SERVICE INFORMATION LETTER SI 01.01

Machines/Models: X20N

PURPOSE: Inspect the Pivot Bolt in the Brake Linkage.

Figure 1

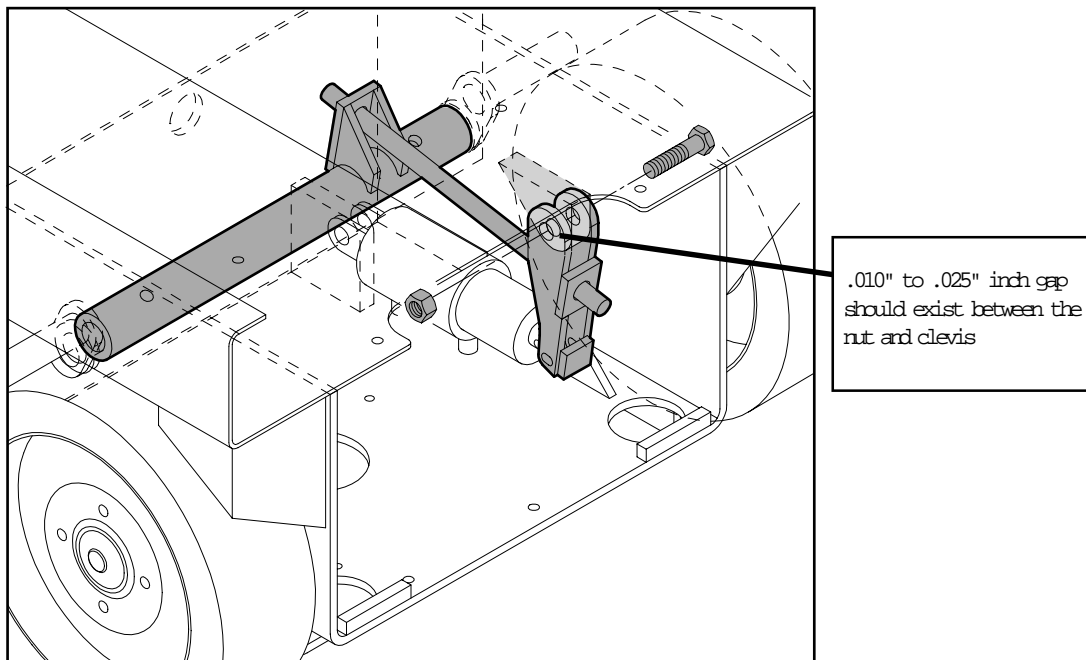
1. The 3/4" bolt in Figure 1 should not be torqued, verify that a gap of .010 to .025" exists between the nut and the side of the brake adjustment weldment.
